Keithley Instruments
28775 Aurora Road
Cleveland, Ohio 44139
1-800-833-9200
tek.com/keithley

Model 2460 High-Current Interactive SourceMeter® Instrument
2460-NFP
2460-RACK
2460-NFP-RACK

VERSION 1.7.12 RELEASE

GENERAL Models affected:

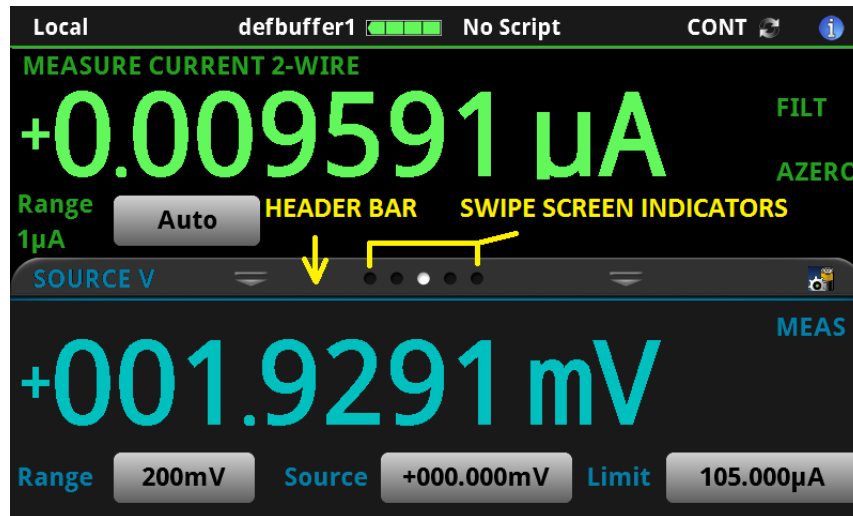
1. Screen Colors: All screen colors have been modified for better contrast and easier readability.
2. Pinch-to-Zoom Performance: Throughout the user interface, the “Pinch-to-zoom” touch screen motion has been improved and is more responsive.
3. Improve Swiping:
 - a. The swipe user interface gesturing has been dramatically improved and is more responsive.
 - b. Added Vertical Swiping in various screens in the GUI.
 - c. Horizontal swiping has been made more smooth and is consistent with Vertical Swiping.
 - d. “Fling” swiping has been implemented where faster swiping actions result in rapid scrolling followed by decay based on the velocity of the “fling.”
 - e. Swipe Down on the Home screen will display larger readings.

4. Tabs and Buttons: Throughout the user interface multiple data display options have been made available through tabs (header bars) with swipe screen indicators to show how many different display options are available and which display tab is active.
